PROJECT NAME: ORANGE BLOSSOM REPLAT #1

PROJECT NUMBER: 2025050013

APPLICATION: PRELIMINARY PLAT #32811

LANDSCAPE AREA DIAGRAM
NOT TO SCALE

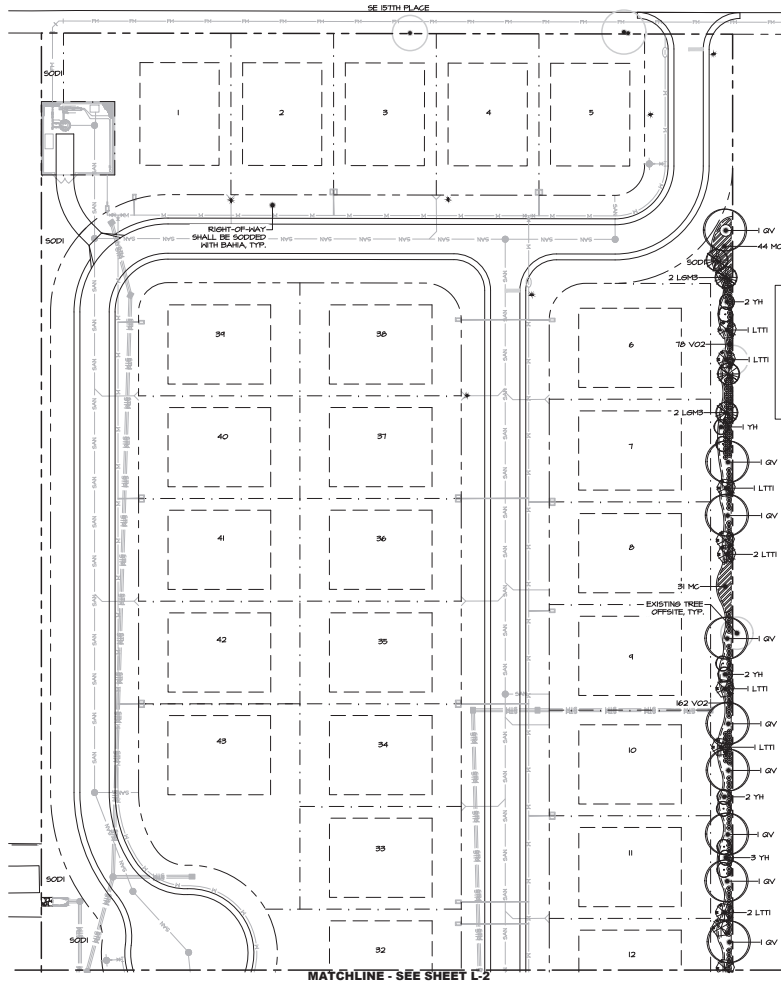
REMARKS: Provide MFLA locations and calculations showing requirement is met

REMARKS: Show location and size of Type C buffer on North Boundary, SE 157th Pl
